SERVICE BULLETIN

TS-940S VCO CARRIER TO NOISE RATIO IMPROVEMENT

3-2-87

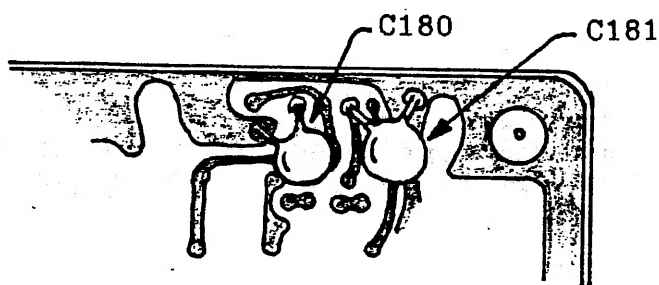
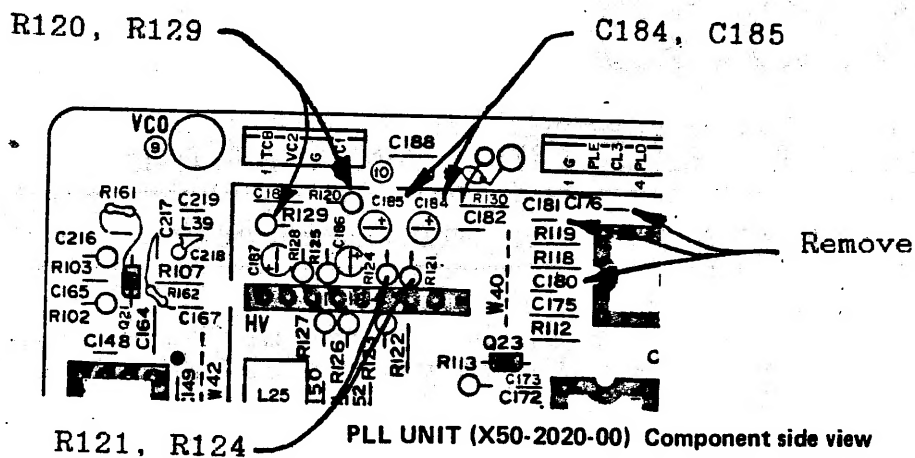
On the PLL UNIT (X50-2020-00) remove capacitors C176, C180, and C181. Change resistors R120 and R129 from 470 ohms to 3.3 K ohms. Change resistors R121 and R124 from 1 K ohm to 680 ohms. Change capacitors C184 and C185 from .22 uF to .33 uF 35V tantalum capacitors. Install C180 and C181 in the positions shown in the accompanying diagrams. The use of new capacitors is recommended to improve reliability, don't try to reuse the old capacitors! Capacitors C181 and C180 should be attached to the foil side of the PLL unit.

RF UNIT

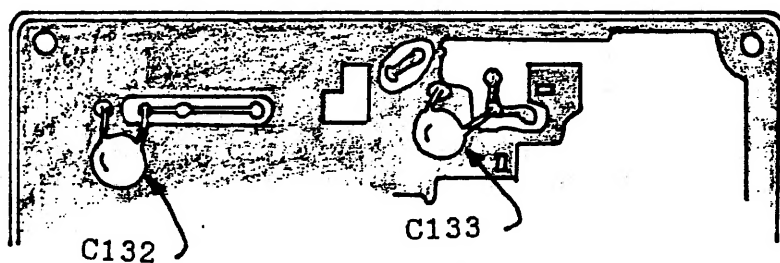
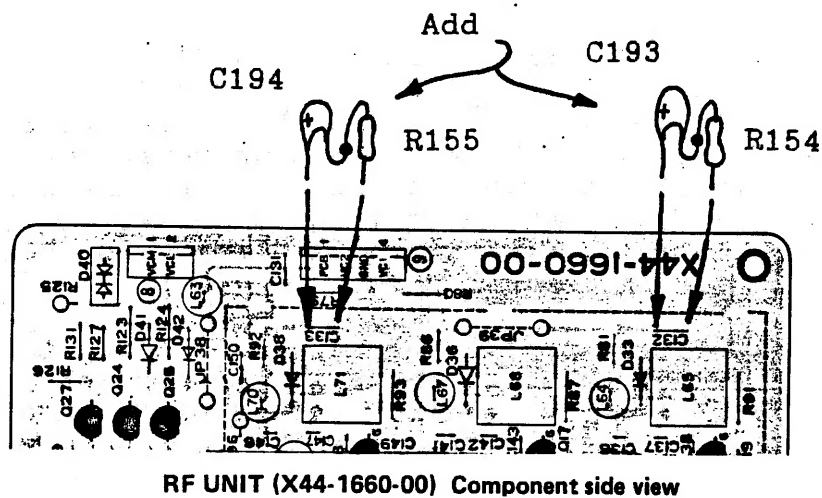
On the RF Unit (X44-1660-00) install the series RC circuits composed of R154 and C193, and R155 and C194, as shown in the accompanying diagrams. As the diagrams illustrate it is easiest to move C132 and C133 to the foil side of the board and install the series RC circuits on the component side.
